Appendix G

Assessment of the refinements to the project

G1 Description of proposed refinements

Figure G.2 Mt Tomah, Mt Wilson and Mt Irvine refined preliminary flight path

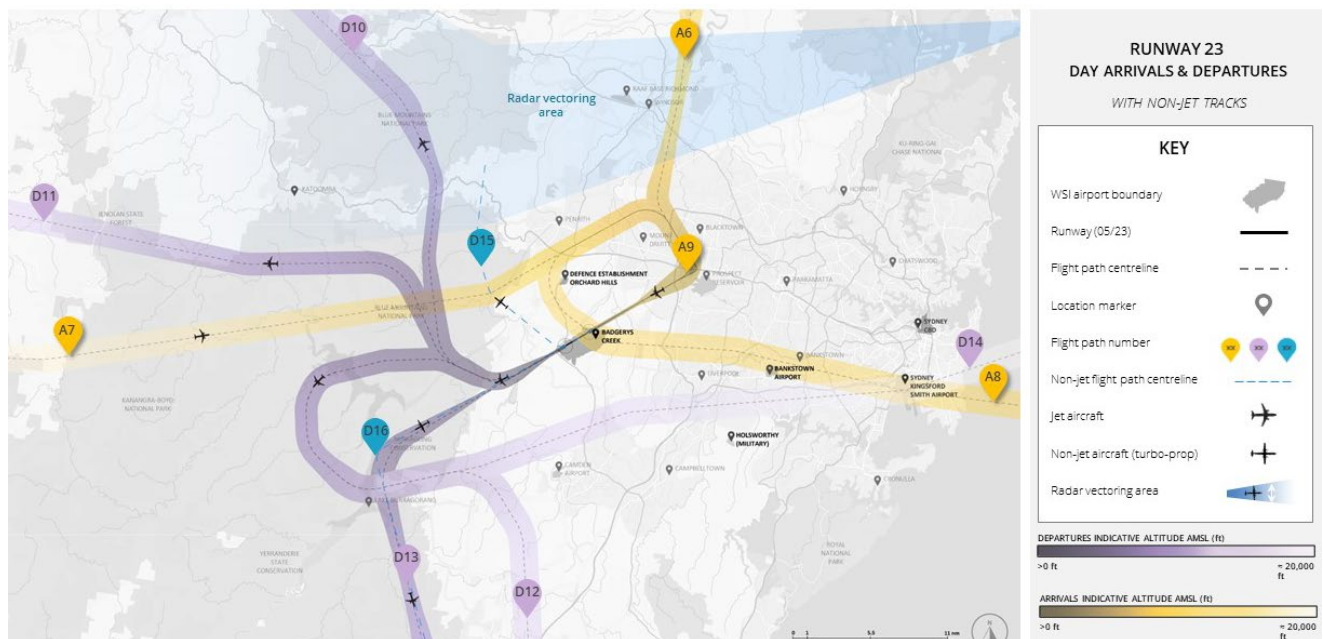
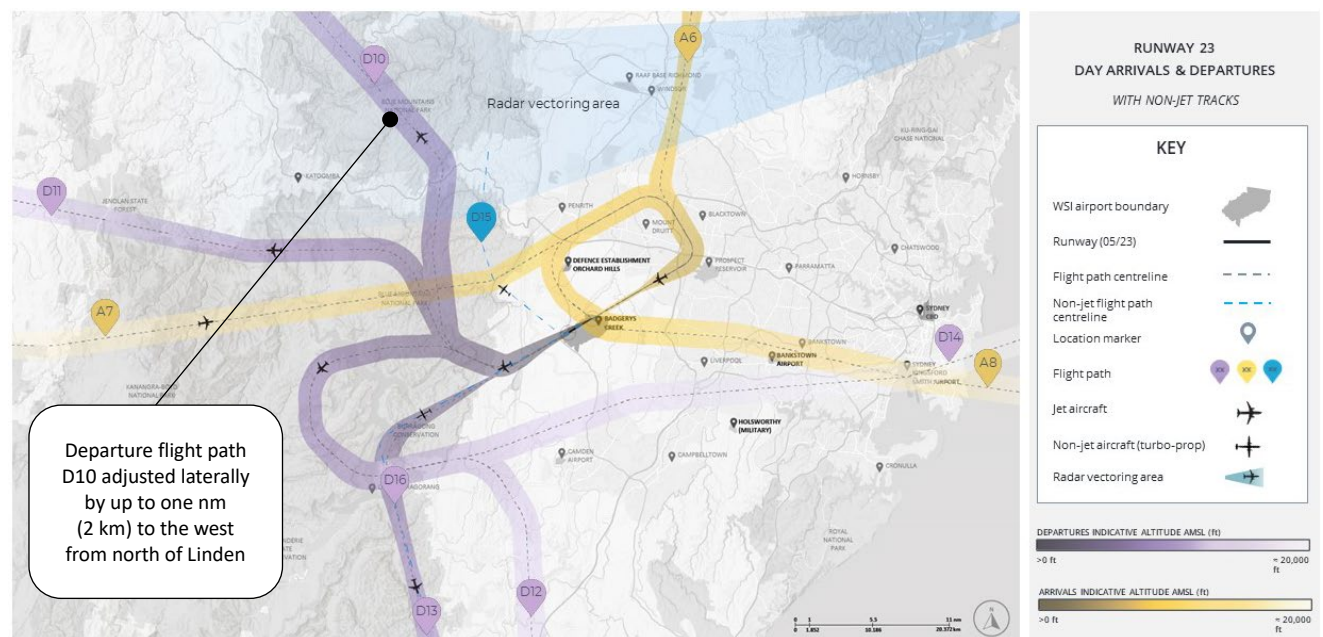
The proposed change would realign a section of the daytime northern jet departures preliminary flight path Runway 23 Departure North Day (preliminary flight path D10) further away from the Mt Tomah, Mt Wilson and Mt Irvine areas. The new alignment would be located to the south and west of the preliminary flight path presented in the Draft EIS and, at the widest point of realignment, be up to around one nm (2 km) further west than the preliminary flight path presented in the Draft EIS.

The realignment would commence from a point over one nm (around 2.5 km) north of Linden (where flights would be at an altitude of around 11,000 ft (3.4 km)) and merge back to the preliminary flight path generally to the east of Lidsdale at around 18,000 ft (5.5 km) (refer to Figure G.1 (Draft EIS) and Figure G.2 (refined flight path)).

- move the Runway 23 northern jet departures preliminary flight path approximately one nm (2 km) further away from Mt Tomah and 0.9 nm (1.8 km) from Mt Wilson/Mt Irvine residential areas, therefore providing additional lateral distance between the preliminary flight path and these communities
- change the location of the preliminary flight path to provide additional lateral separation between the preliminary flight path and the Emu Cave Aboriginal Place site
- not increase the required fuel burn from aircraft (due to increased flight length) or reduce airport efficiency compared to the preliminary flight path presented in the Draft EIS.

Figure G.4 Required Navigation Performance – Approval Required approach removal

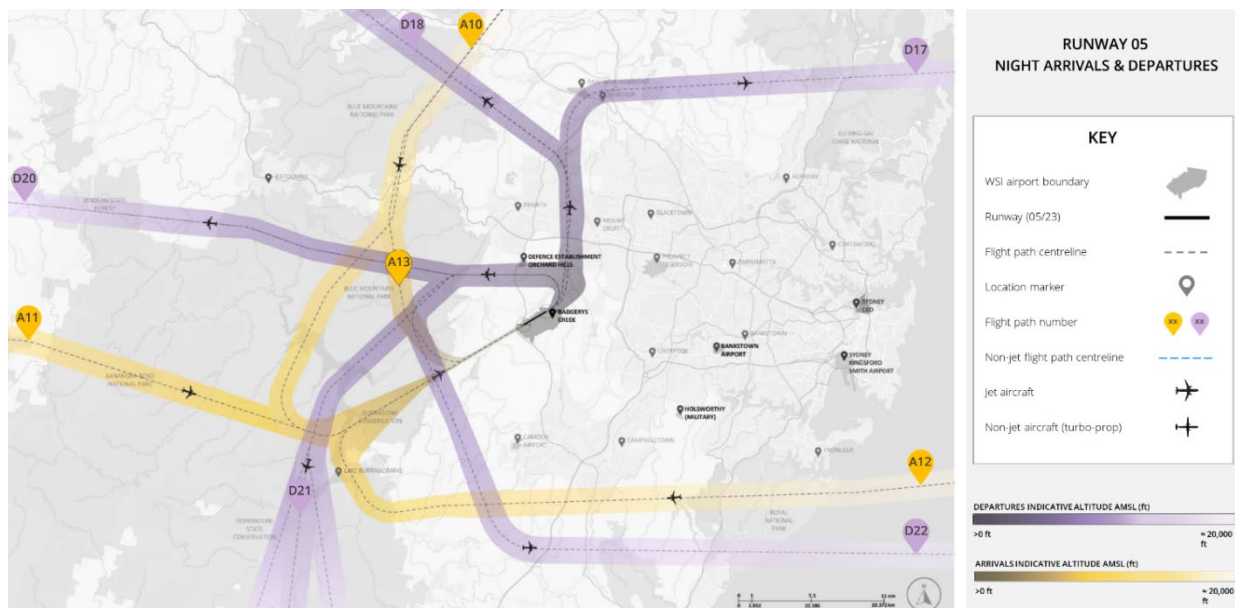
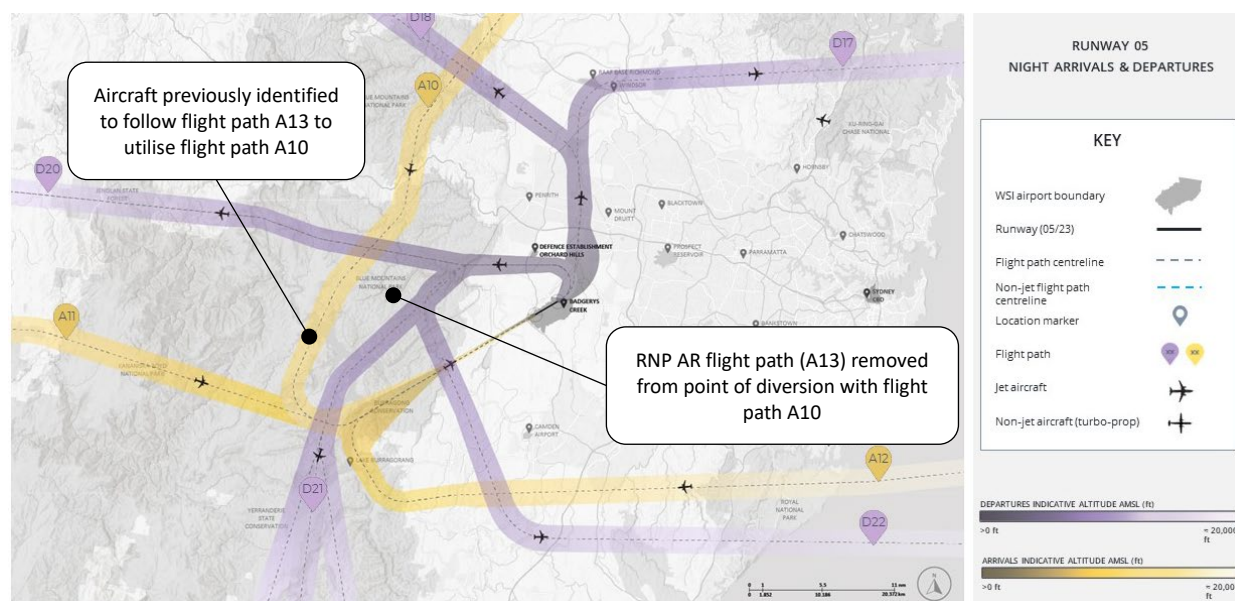
The proposed change would remove the Required Navigation Performance – Approval Required (RNP AR) preliminary flight path (Runway 05 Arrival (RNP) North Night – preliminary flight path A13) identified in the Draft EIS during night time periods (refer to Figure G.3). Flights approaching WSI would instead utilise the alternative preliminary flight path A10 (refer to Figure G.4) as presented in the EIS.

Removal of the RNP AR approach flight path at night would result in an increase in the altitude of aircraft which fly over the residential areas on this approach. In particular, removal of the RNP AR approach flight path and use of the Runway 05 Arrival North Night flight path (preliminary flight path A10) would result in all aircraft on this approach path flying over Linden and Woodford at a height of around 12,000 ft (3.7 km) rather than around 5,000 ft (1.5 km), which would occur on the proposed RNP AR approach flight path as described in the Draft EIS.

Figure G.6 RRO night approach to Runway 05 refined preliminary flight path

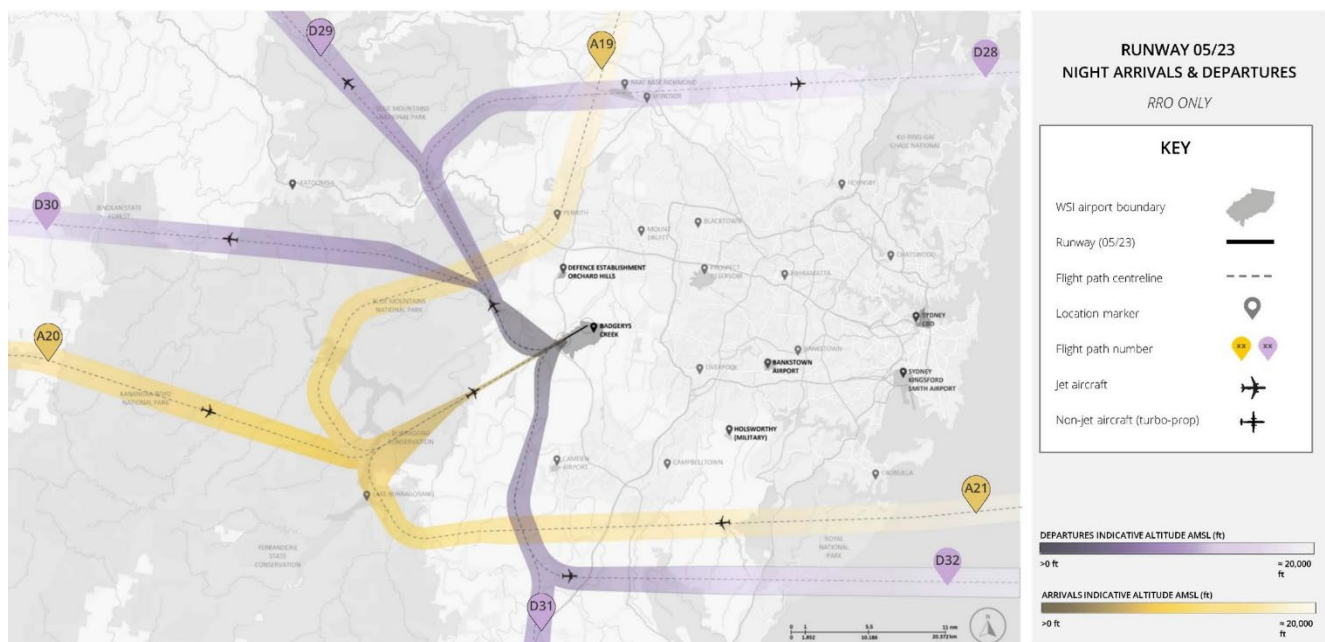
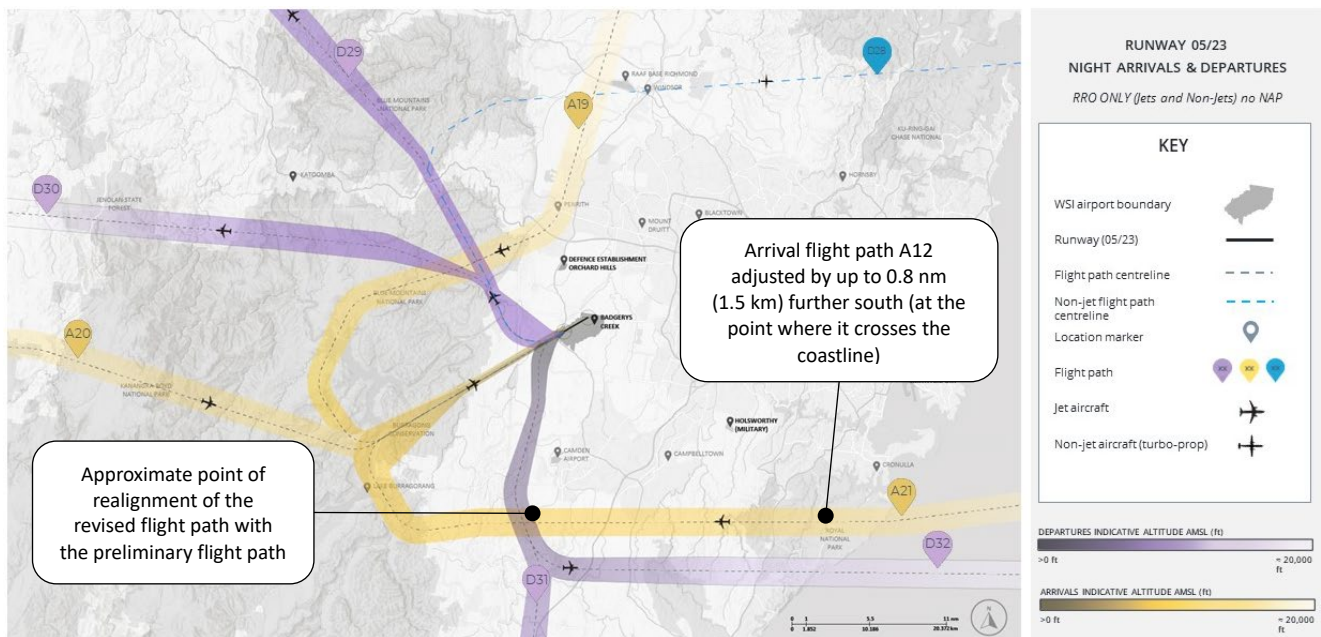
The proposed change would move the Runway 05 Arrival East Night flight path (preliminary flight path A21) that approaches WSI from the east around 0.8 nm (1.5 km) further south at the point where it crosses the coastline south of Bundeena. Arriving aircraft at the point south of Bundeena would be at an altitude around 15,000 ft (4.5 km) (refer to Figure G.5 (Draft EIS) and Figure G.6 (refined flight path)).

The revised flight path would continue to provide separation between the arrival (A21) and departure (D22) preliminary flight paths. The realigned preliminary flight path would merge with the preliminary flight path at a point near the suburb of Mount Hunter (at an altitude of around 9,000 ft (2.7 km)). From this point, the revised flight path would continue to WSI along the same flight path alignment as presented in the Draft EIS (A21).

The proposed refinement to the flight path would result in a series of benefits compared to the preliminary flight path presented in the Draft EIS. The proposed refinement would reduce the level of direct community overflight to communities such as Bundeena.

Figure G.8 Refined RRO runway mode of operation flight paths, RRO-NAP and proposed radar vectoring area

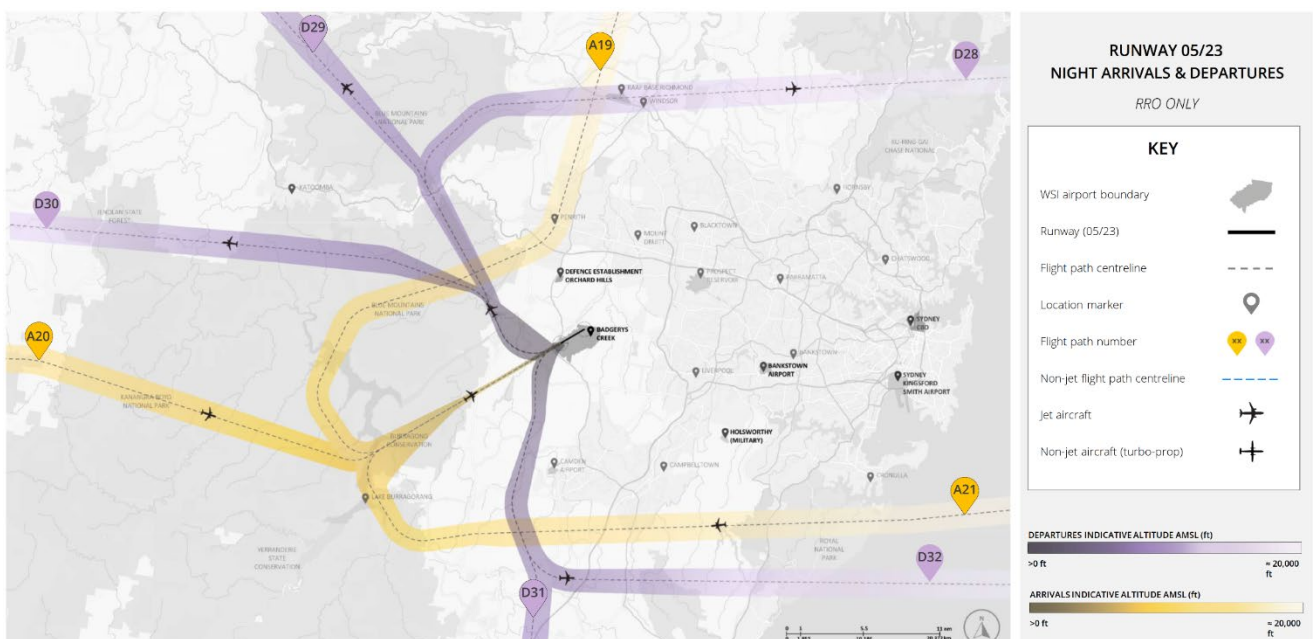
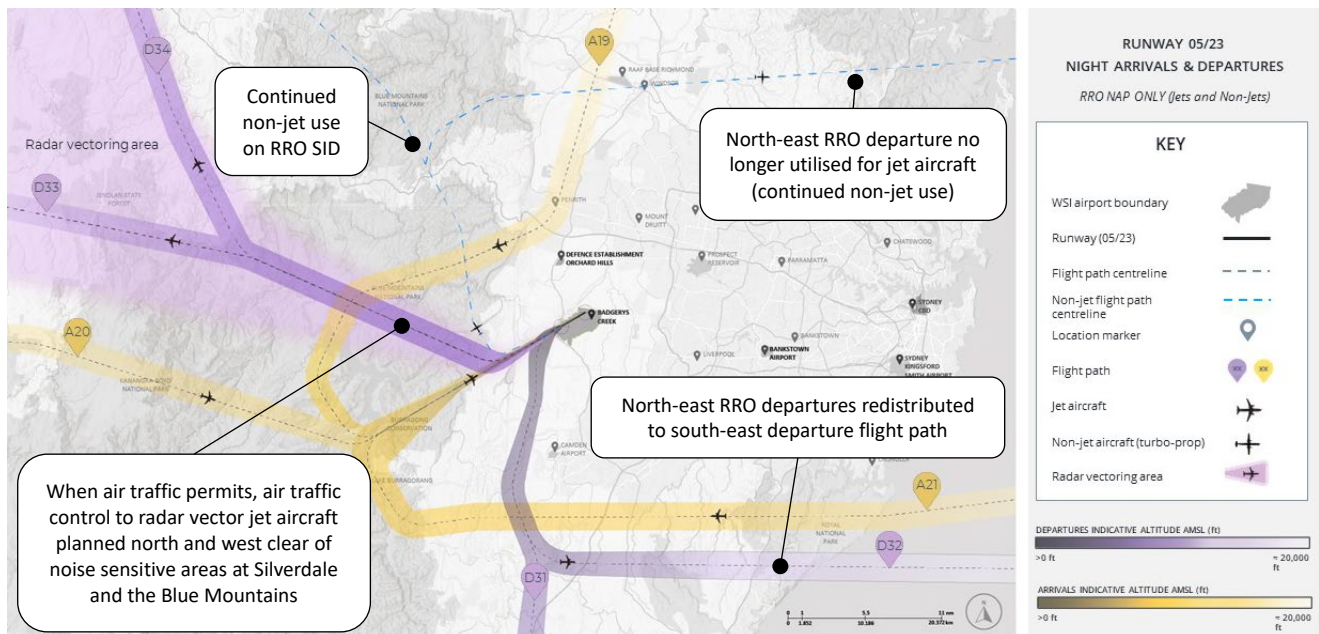
This change would discontinue use of the Runway 23 Departure Northeast Night (RRO) flight path (preliminary flight path D28) for jet aircraft. All jet traffic previously assigned jet aircraft along the Runway 23 Departure Northeast Night (RRO) flight path would be redistributed to the Runway 23 Departure Southeast Night (RRO) (preliminary flight path D32). The reassigned traffic includes all eastern departures to destinations in New Zealand, Pacific Island countries and the USA.

The change to the Runway 23 Departure Northeast Night (RRO) preliminary flight path would not affect non-jet aircraft which would continue to use this flight path (refer to Figure G.8).

This change would include the introduction of a new night-time (11 pm to 5:30 am) RRO noise abatement procedure (RRO-NAP). Under the proposed new RRO-NAP, northbound and westbound departure aircraft will maintain the Runway 23 straight ahead runway heading (230 degrees) flight path for approximately 5 nm (9.3 km) rather than immediately turning as soon as safely possible. This would result in avoiding overflights of communities as much as possible, including Wallacia and Mulgoa. However, the RRO-NAP would result in additional overflight of parts of Silverdale and Warragamba.

The flight paths depicted are indicative. Air traffic control will radar vector aircraft along paths similar to these tracks as indicated by the shaded area in Figure G.8.

Figure G.11 Differential contours – N60 Night (11 pm to 5.30 am) – 2055

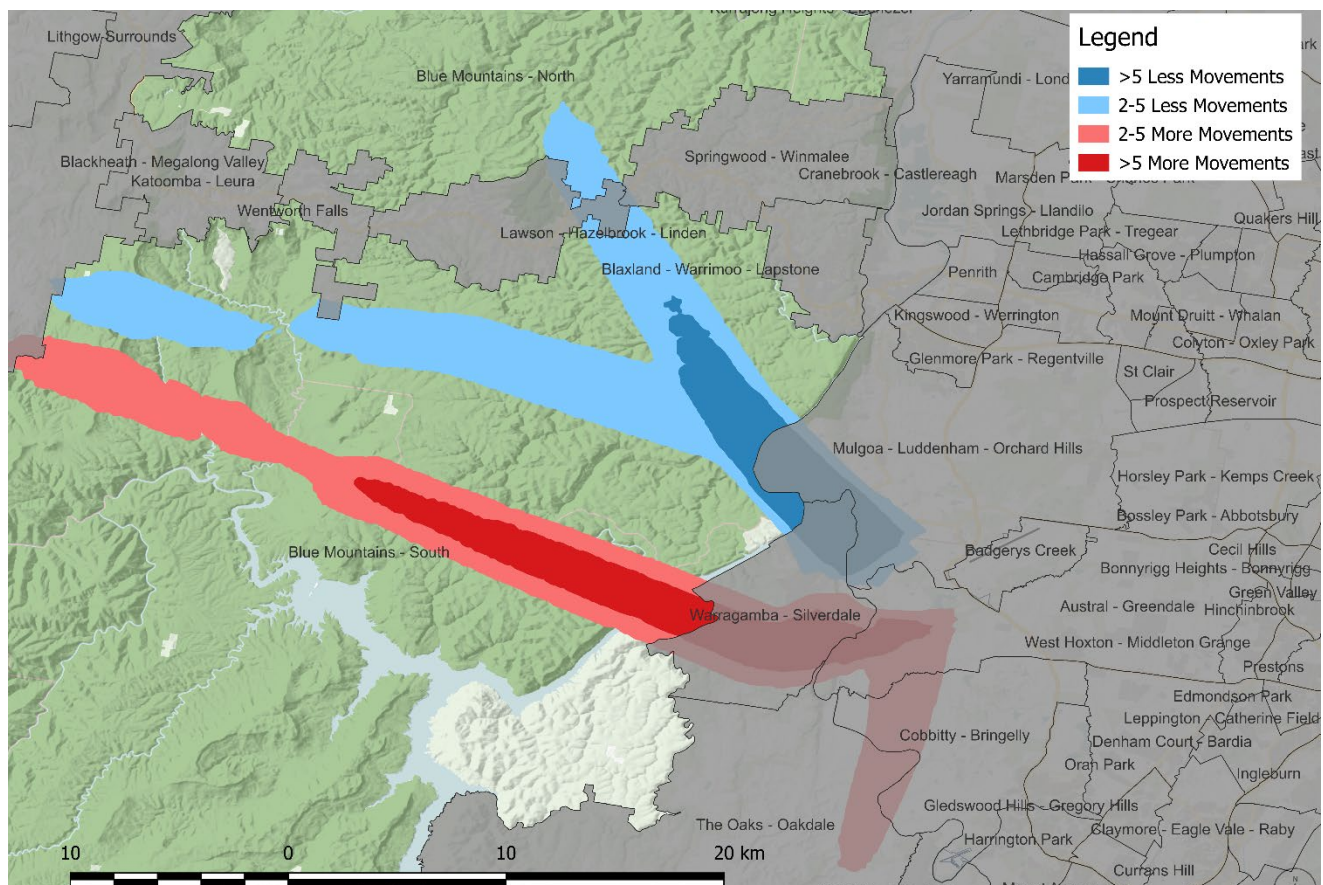
The changes proposed in the RRO flight paths have potential to generate the previously identified noise impacts on the GBMA. The proposed changes redistribute a portion of the traffic further south over a different region of the GBMA. The shift in the aircraft producing at least 60 dB(A) is shown in Figure G.11. As presented in Figure G.11, blue shaded areas are anticipated to result in at least 2 less movement whereas red areas are anticipated to result in at least 2 additional movements of at least 60 dB(A) compared to the assessment presented in the Draft EIS. The selection of 2 movements is based on a likely threshold of noticeability in the number of aircraft overflights.
